STATE OF NORTH CAROLINA
DEPARTMENT OF TRANSPORTATION

August 14, 2008

Subject: **Application for Modification to Individual Permit** for NC 16 from north of SR 1386 in Lincoln County to North of SR 1895 in Catawba County. Federal Aid Project No. STP-F-24-1(34) State Project No. 8.1830501. **TIP Project No. R-2206B/C.** \$570.00 Debit from WBS Element No. 34383.1.5.

MODIFICATION
Permit Drawing
Sheet 2 of 5
(Revised July 2008)

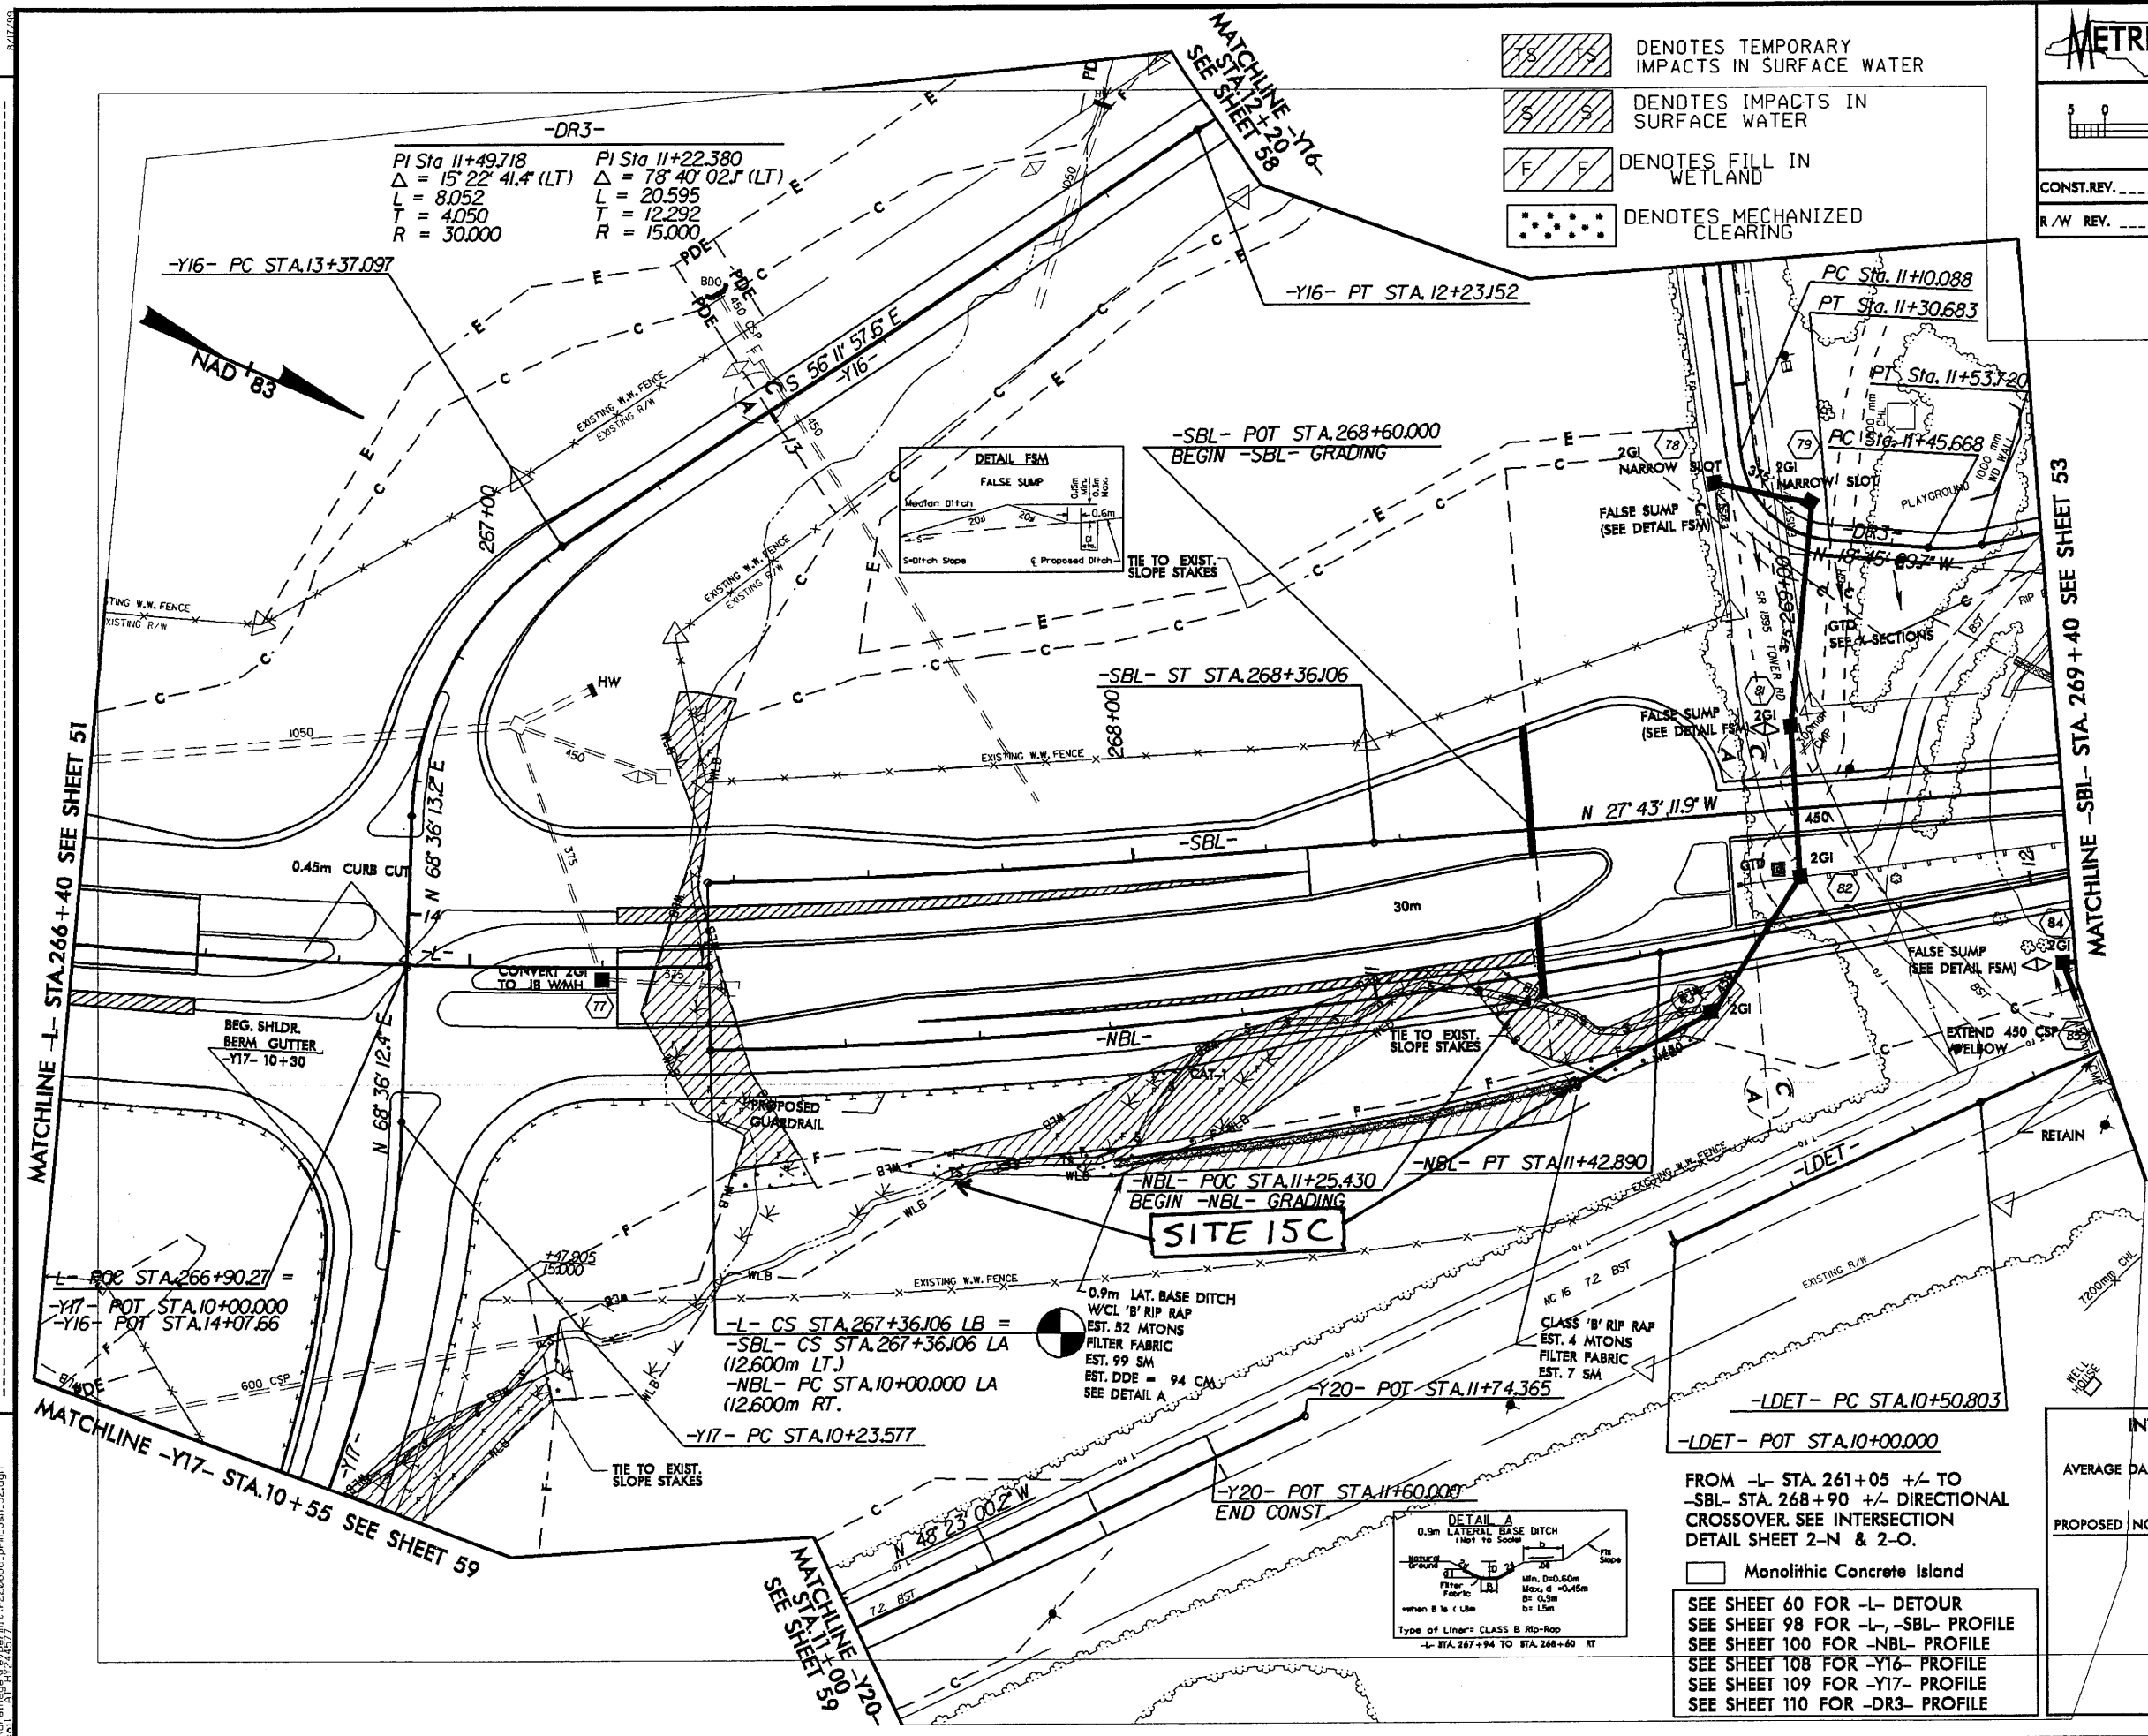
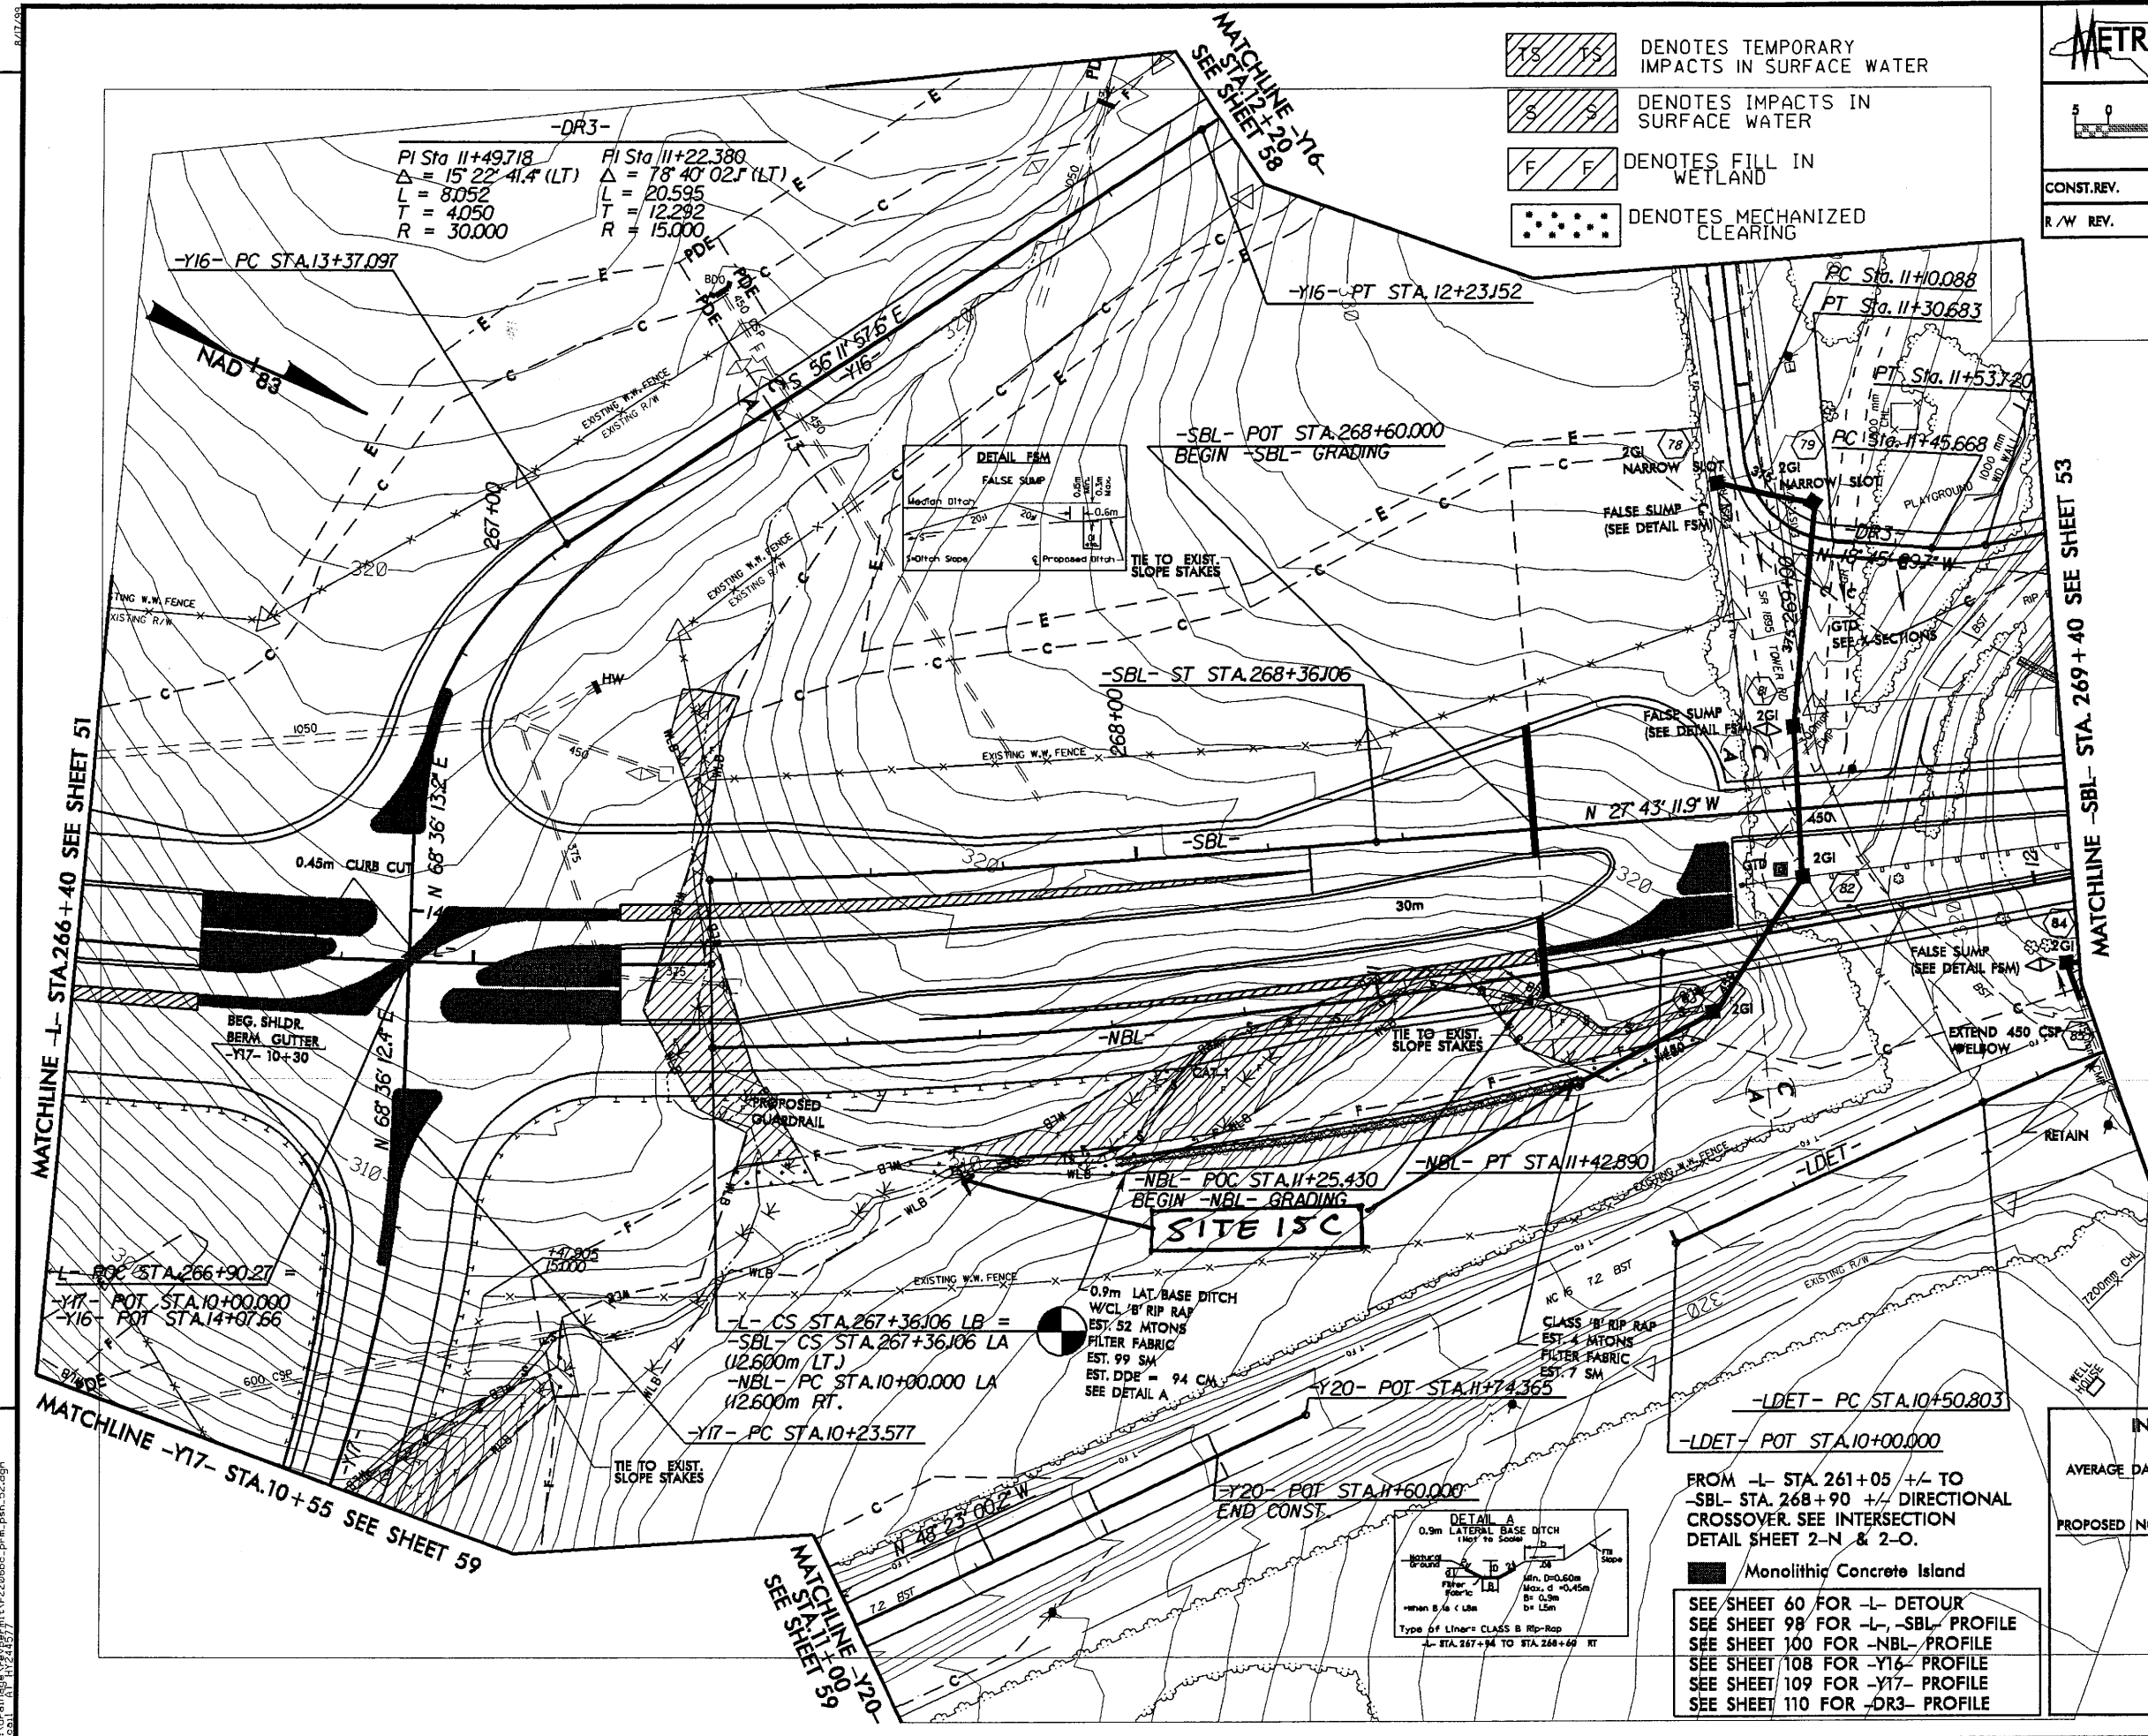
Permit Site 15C, Station -L- 267+70 to 11+54-L-RT

To improve the stability of the ditch at this site, NCDOT has re-designed the ditch from a V-ditch originally permitted to a Lateral Base Ditch. There is no change to the permanent wetland or stream impacts at this site associated with the re-designed ditch. There are 82 feet of temporary stream impacts to an unnamed tributary (UT) to Reedy Creek associated with tying in the ditch. The temporary impacts are depicted on Mod Sheets 2 & 3 of 5, and require no mitigation.

Temporary Impacts: 82 linear feet of temporary stream impact not previously accounted for.
